Re: Submission Review: 60th Avenue at Box Elder – Infrastructure Site Plan
Application Number: DA-1478-14
Case Numbers: 2024-6039-00

THIRD SUBMISSION REVIEW

BOX ELDER INFRASTRUCTURE SITE PLAN

COVER

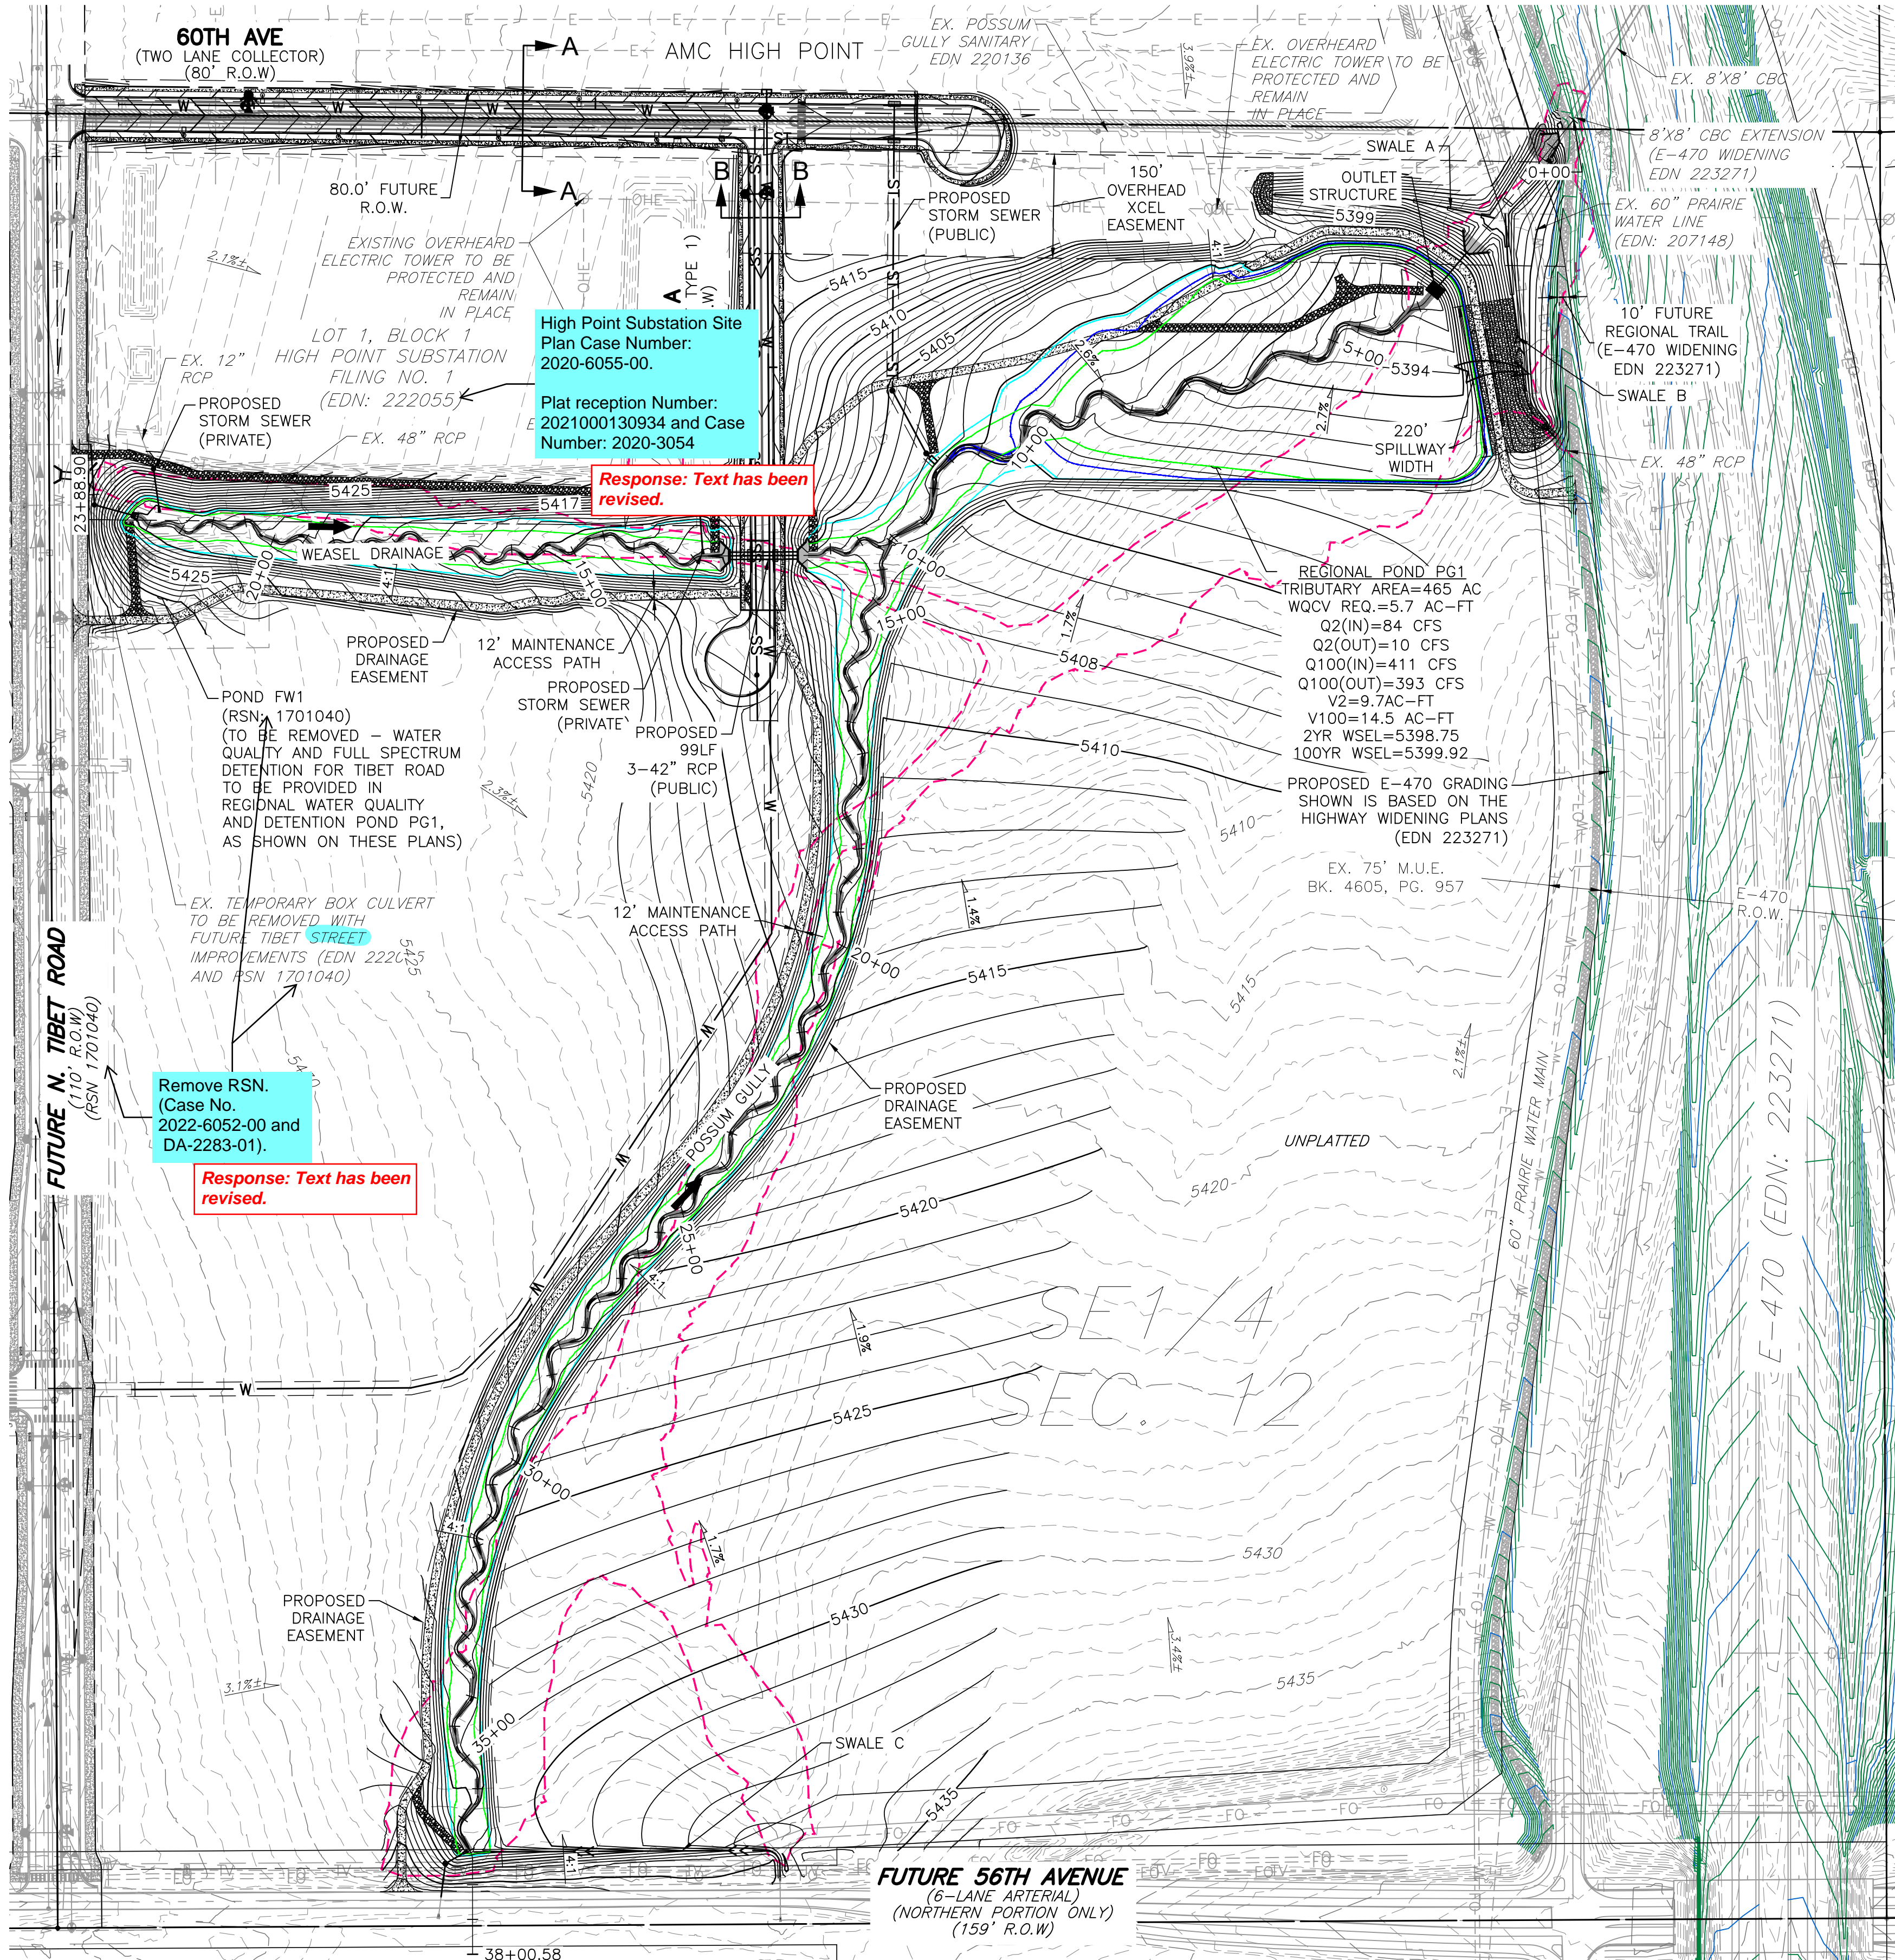
2B. Sheet 1: Remove the PROS signature line from the approval block.

Response: PROS signature lines removed from approval block.

OVERALL

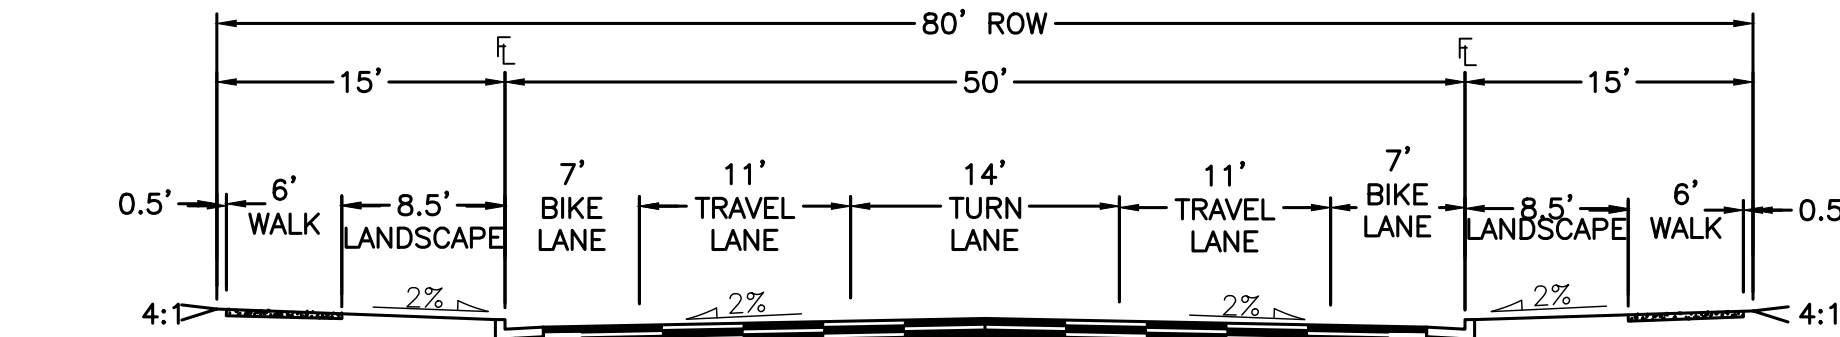
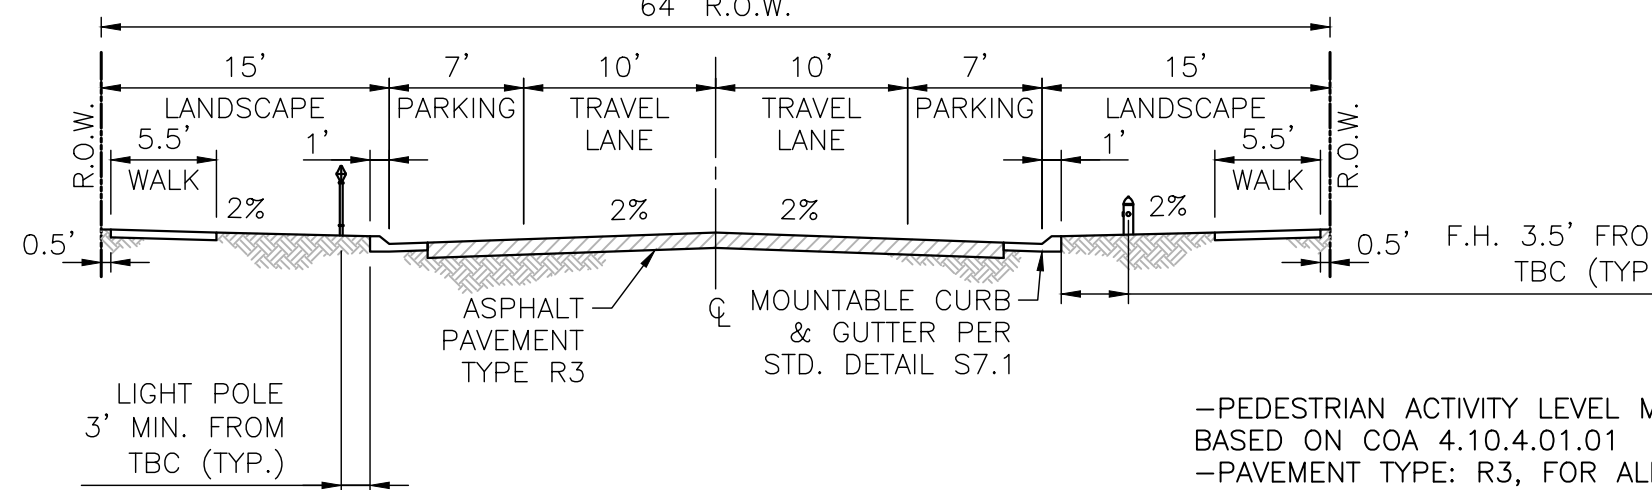
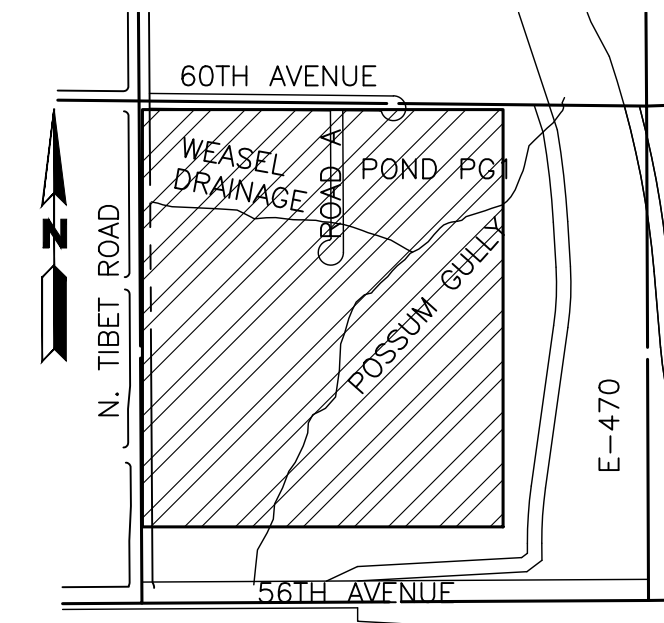
2C. Sheet 2: Add plat and site plan information for substation: High Point Substation Site Plan Case Number: 2020-6055-00. Plat reception Number: 2021000130934 and Case Number: 2020-3054

2D. Sheet 2: Revise Tibet "Street" to "Road".

2E. Sheet 2: Remove RSN. (Case No. 2022-6052-00 and DA-2283-01).

Response: Plat and site plan information added for High Point Substation.

Response: Tibet Street now 'N. Tibet Road'.

Response: RSN has been removed.

SITE PLAN 60TH AVENUE

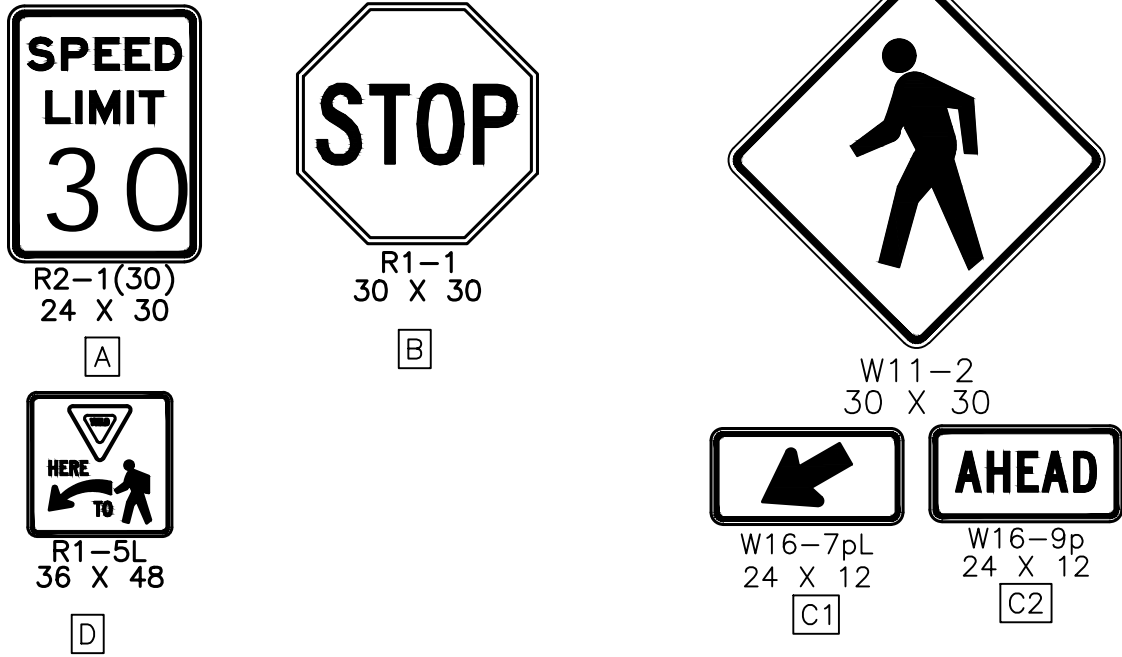
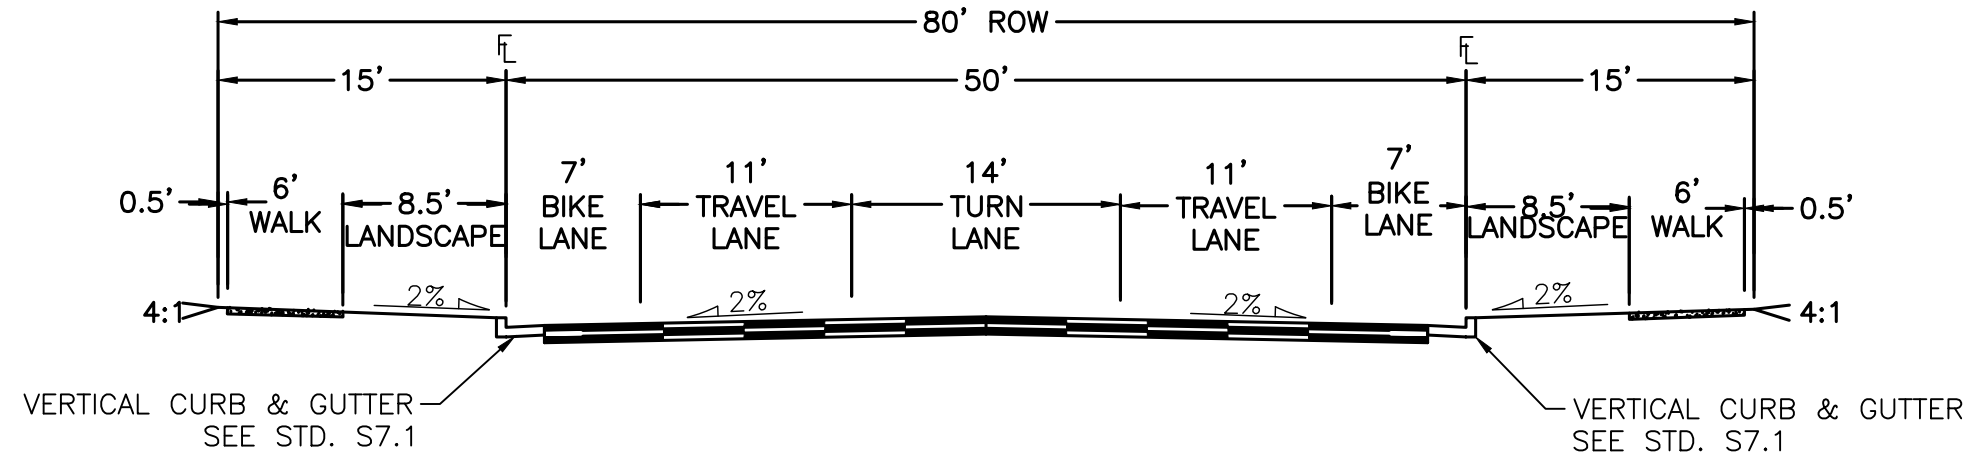
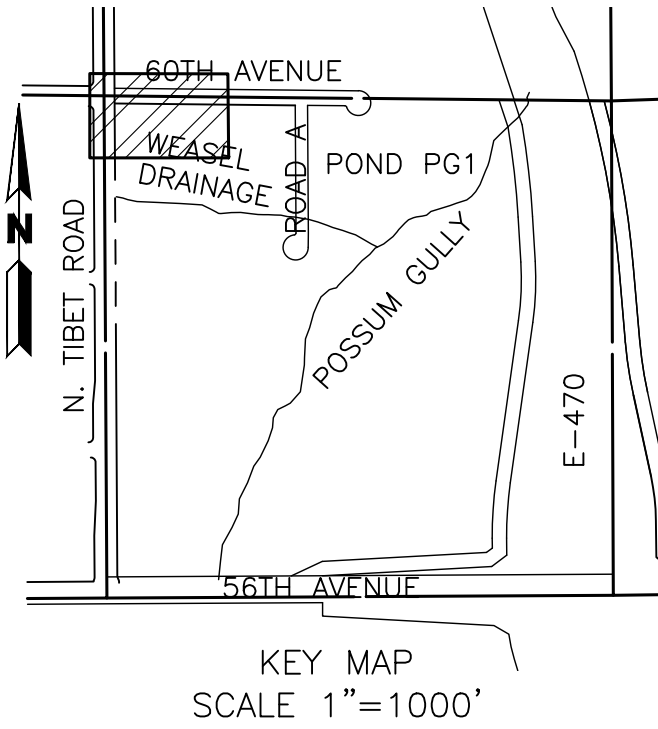
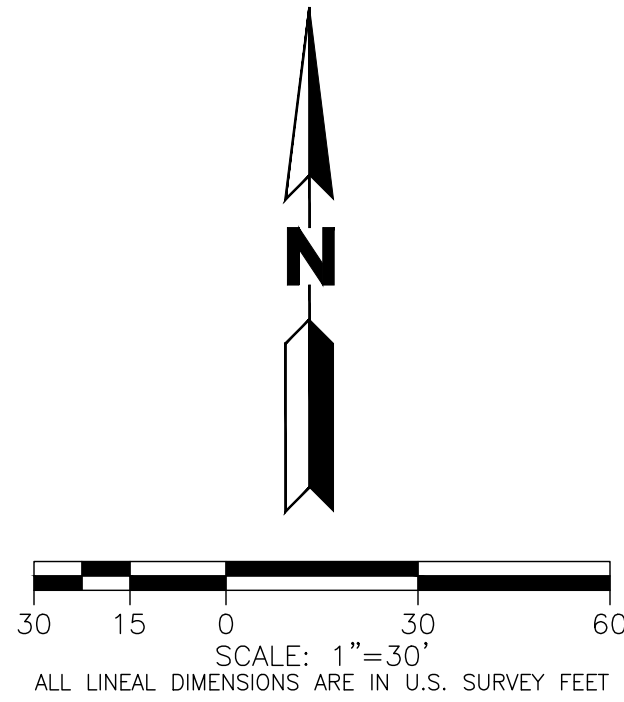
2F. Sheet 3: Revise to N. Tibet Road.

Response: Tibet Street now 'N. Tibet Road'.
